RE: Traffic Assessment – 75 Station Lake Road Lara VIC 3212

This letter has been prepared to formally address the City of Greater Geelong's Development Engineering Unit's RFI items for access and parking at the proposed site, 75 Station Lake Road Lara:

drawing PA 04 PROPOSED SITE PLAN

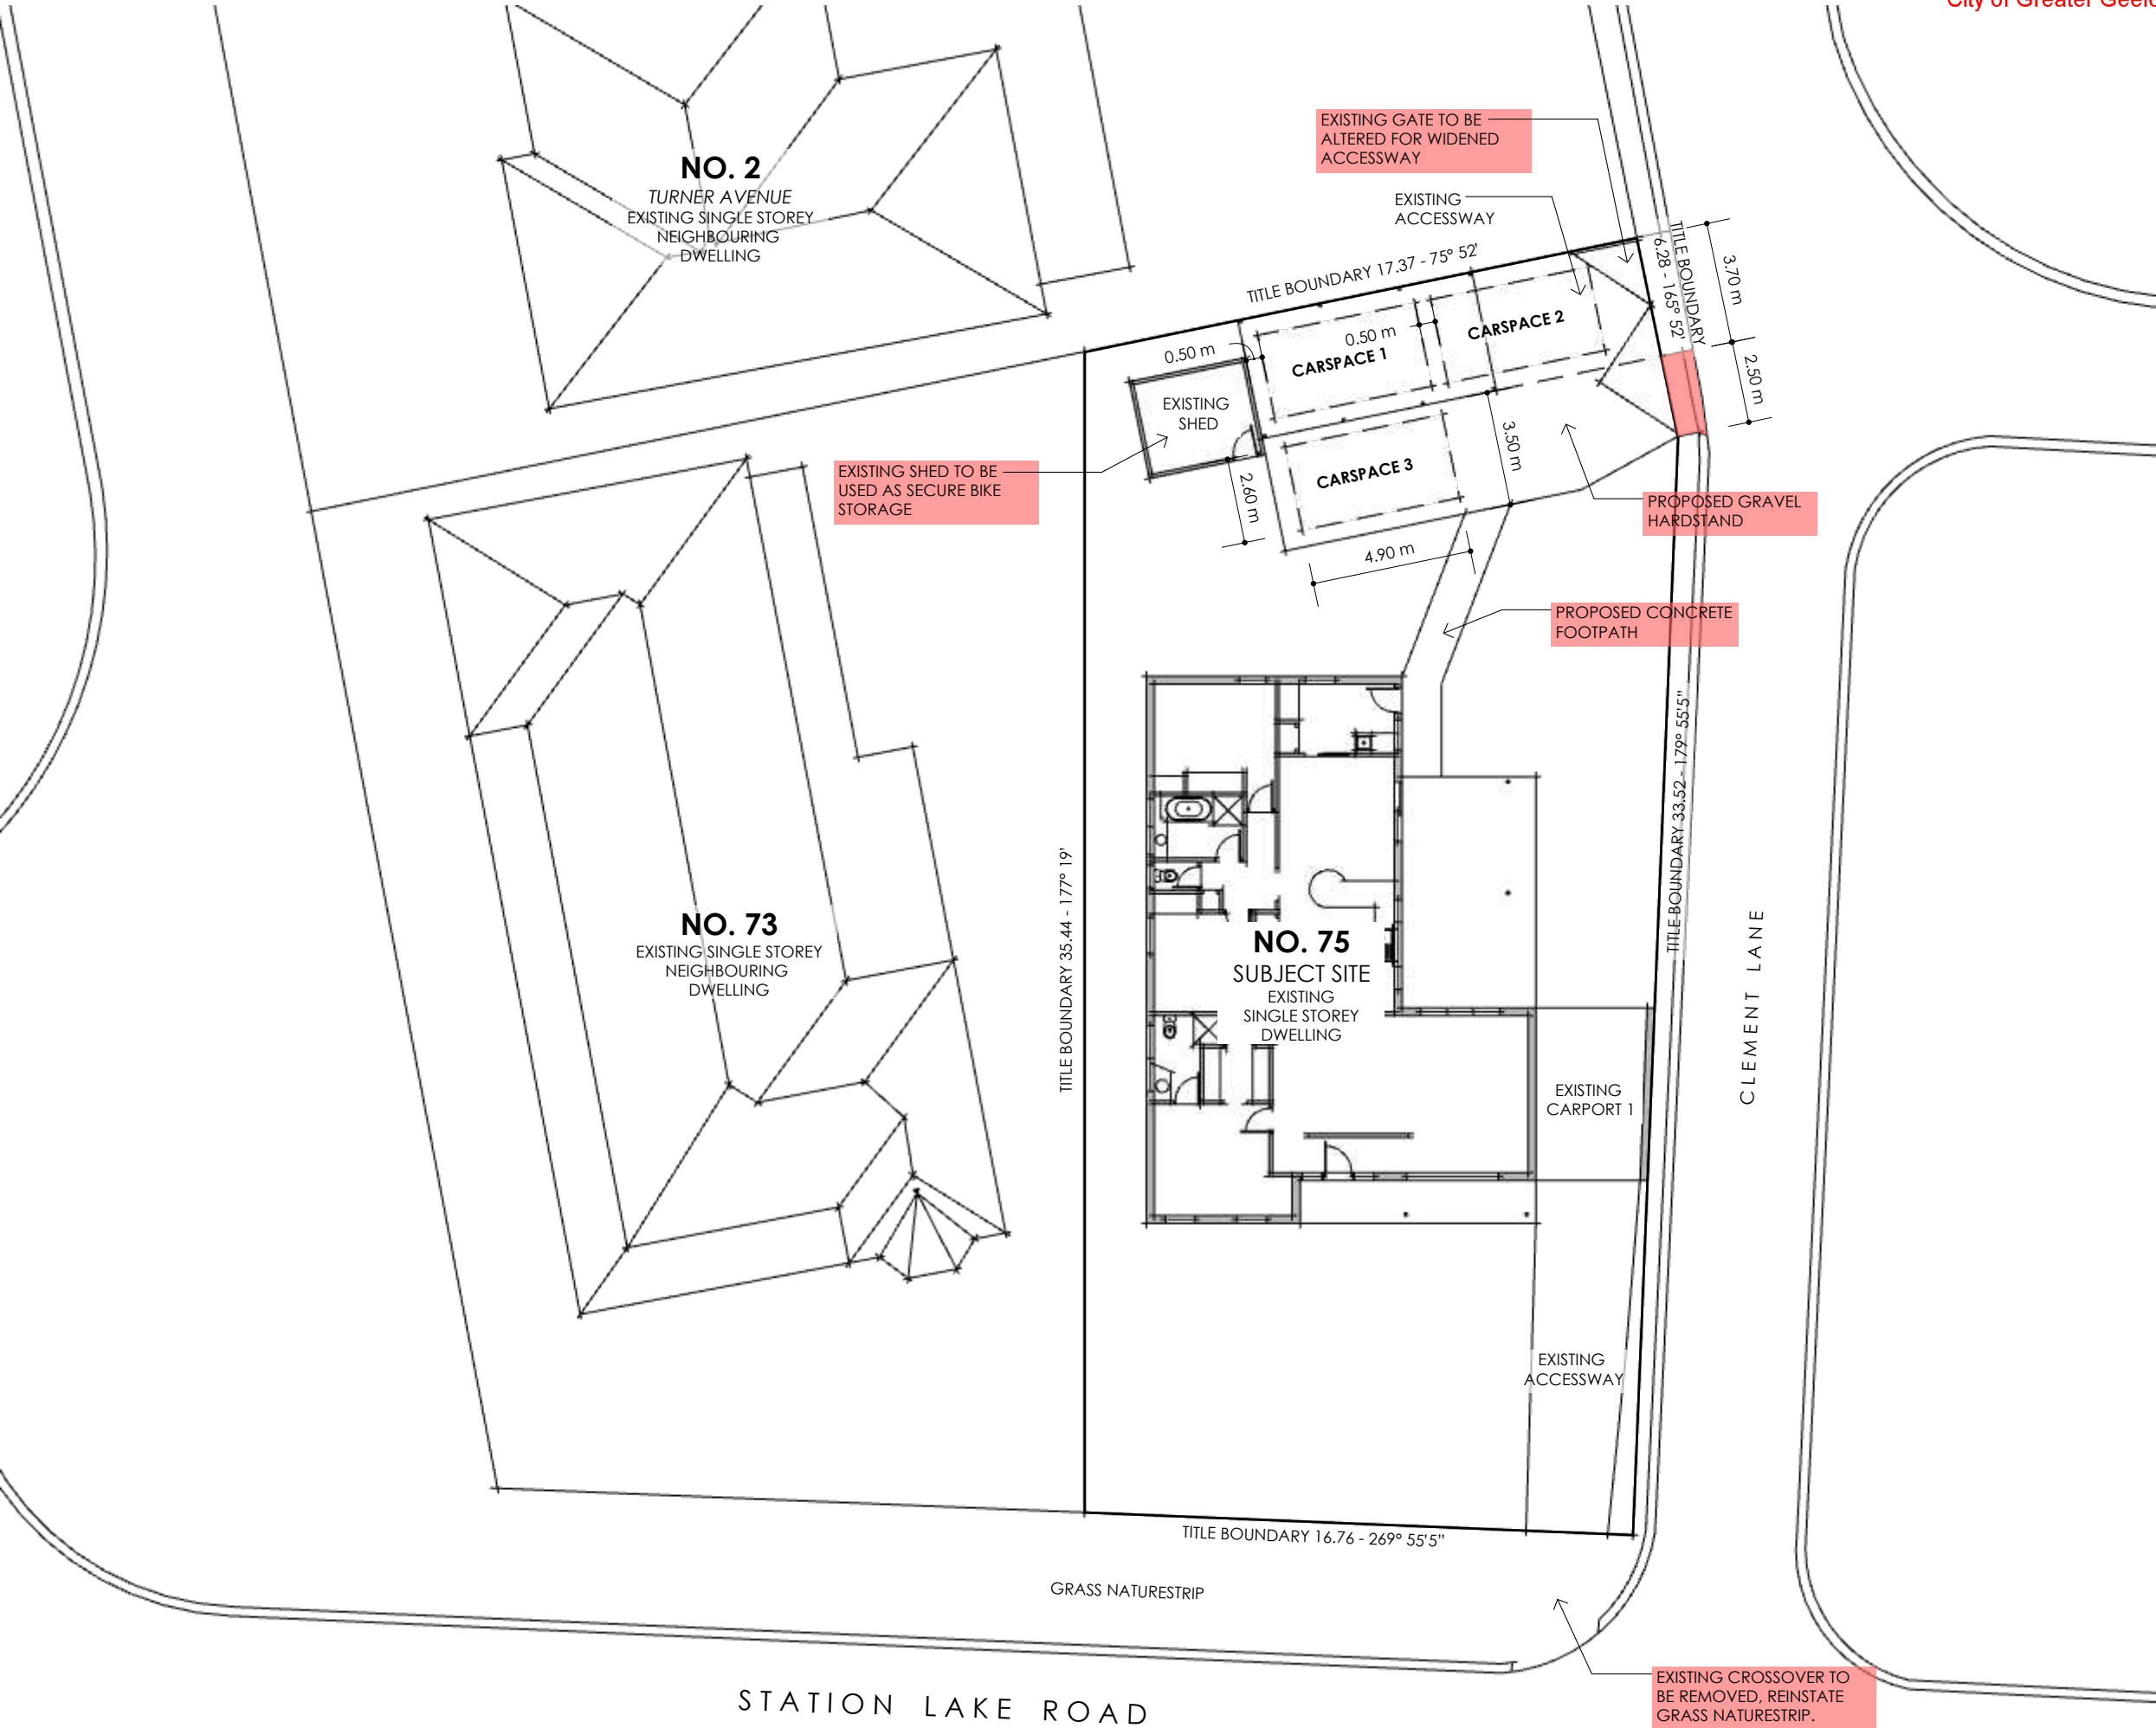
- 1. The existing crossing from Station Lake Road, as shown on the plans, is a pram crossing and not an approved vehicle crossing. Vehicle access via the pram crossing is not permitted. The nature strip between the property boundary and the pram crossing must be reinstated and clearly shown on the plans.*

- 2. Vehicle access to Existing Carport 1 must be provided from Clement Lane.*
- 3. The proposed 6.2 m wide vehicle crossing is not supported. The vehicle crossing must be reduced to 4.0 m in width unless a wider crossing can be justified by swept path analysis demonstrating the operational need. Typical council requirements generally limit vehicle crossing widths within residential unless a larger width is supported by engineering evidence.*

- 4. Corner visibility splays must be provided on both sides of the proposed vehicle crossing at Clement Lane to improve sight distance and ensure the safe entry and exit of vehicles.*

- 5. All vehicles must enter and exit the site via the designated vehicle crossing on Clement Lane only. Vehicle access from Station Lake Road is not permitted.*

- The ease and safety with which vehicles access and circulate within the parking area.*
- The provision for pedestrian movement within and around the parking area.*
- The provision of parking facilities for cyclists and disabled people.*
- Whether the layout of car parking spaces and access lanes is consistent with the specific standards or an appropriate variation.*
- Whether the layout of car spaces and accessways are consistent with Australian Standards AS2890.1-2004 (off street) and AS2890.6-2009 (disabled).*

RFI 28.07.26
- EXISTING FRONT INFORMAL CROSSOVER REMOVED & GRASS NATURESTRIP REINSTATED
- CARPARKING POSITIONS ALTERED AS PER DFC ENGINEERINGS RECOMMENDATIONS
- EXISTING SHED TO BE SECURE BIKE STORAGE
- FOOTPATH PROPOSED FROM CARPARKING TO BUILDING

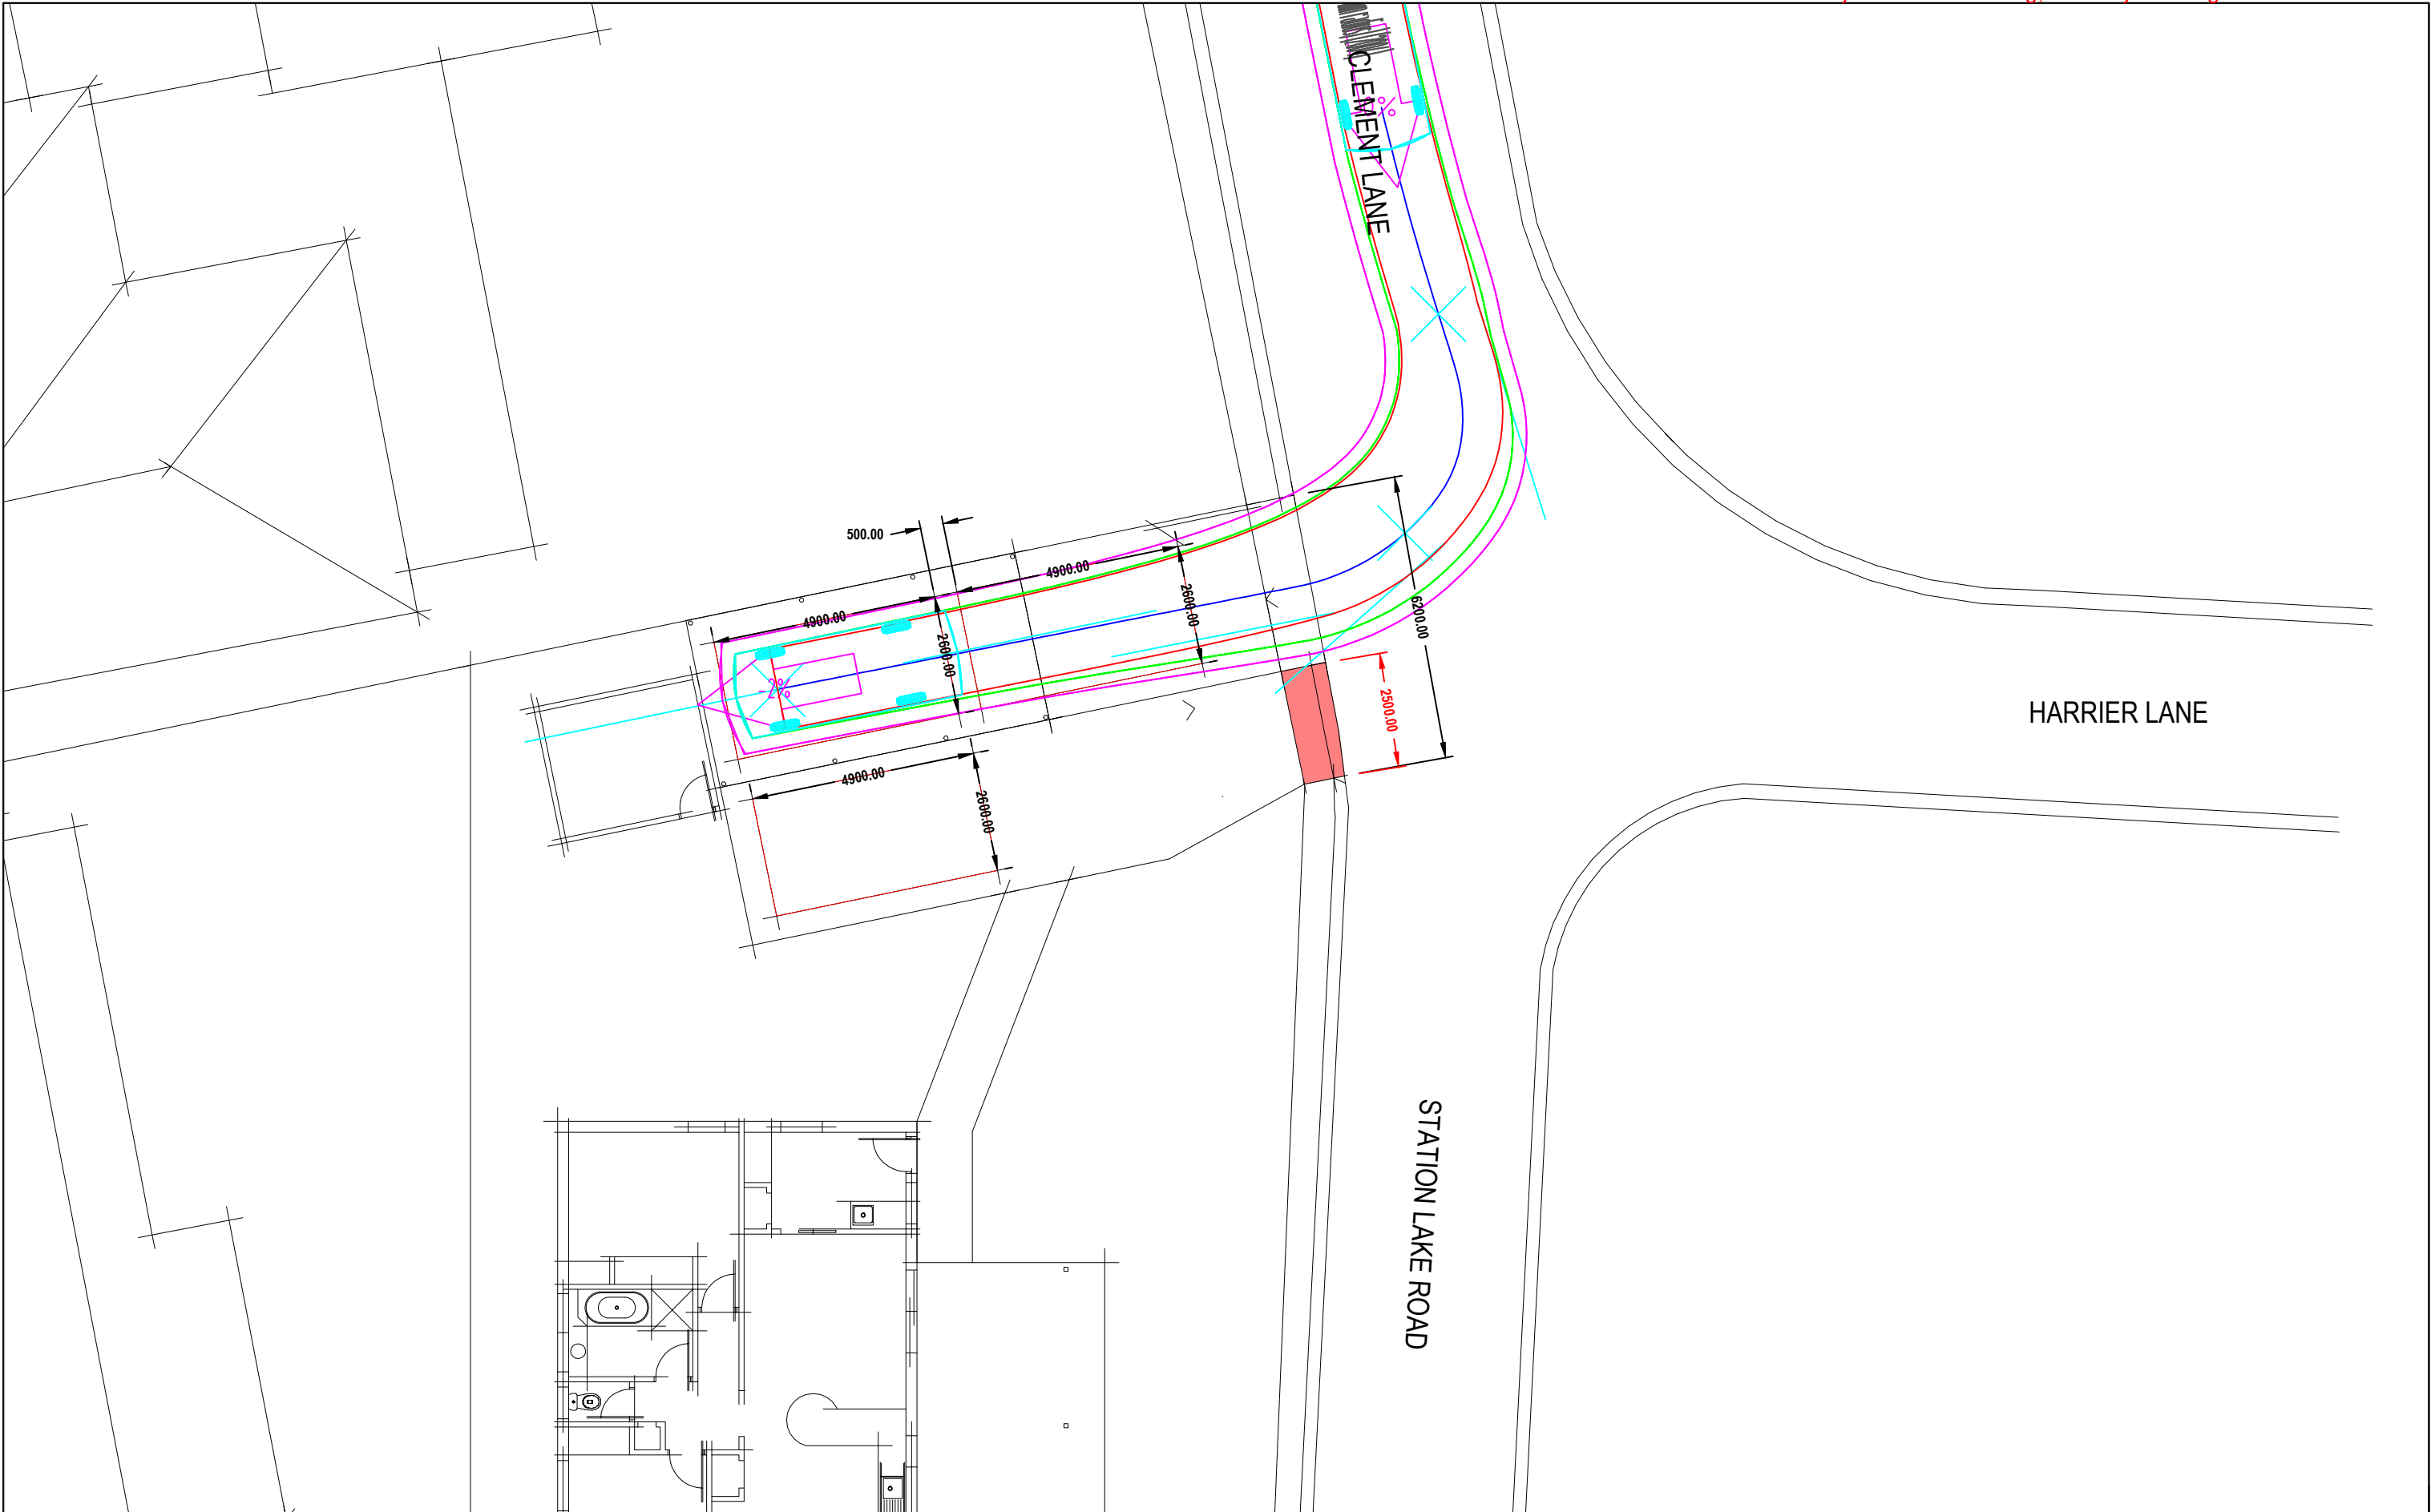
- *The vehicle crossing must be reduced to 4.0 m in width unless a wider crossing can be justified by swept path analysis demonstrating the operational need. Typical council requirements generally limit vehicle crossing widths within residential unless a larger width is supported by engineering evidence.....*
- *Whereby a crossover greater than 4m is proposed engineering evidence (swept path analysis) to support the wider width along with an amended car park design.*

- **Dwg 26.42-0001:** Space 1 Entry
- **Dwg 26.42-0002:** Space 2 Entry
- **Dwg 26.42-0003:** Space 3 Entry
- **Dwg 26.42-0004:** Space 1 Exit
- **Dwg 26.42-0005:** Space 2 Exit
- **Dwg 26.42-0006:** Space 3 Exit

- A B85 design vehicle can successfully and safely enter each proposed car parking space in accordance with AS2890.1:2004 and the Greater Geelong Planning Scheme.
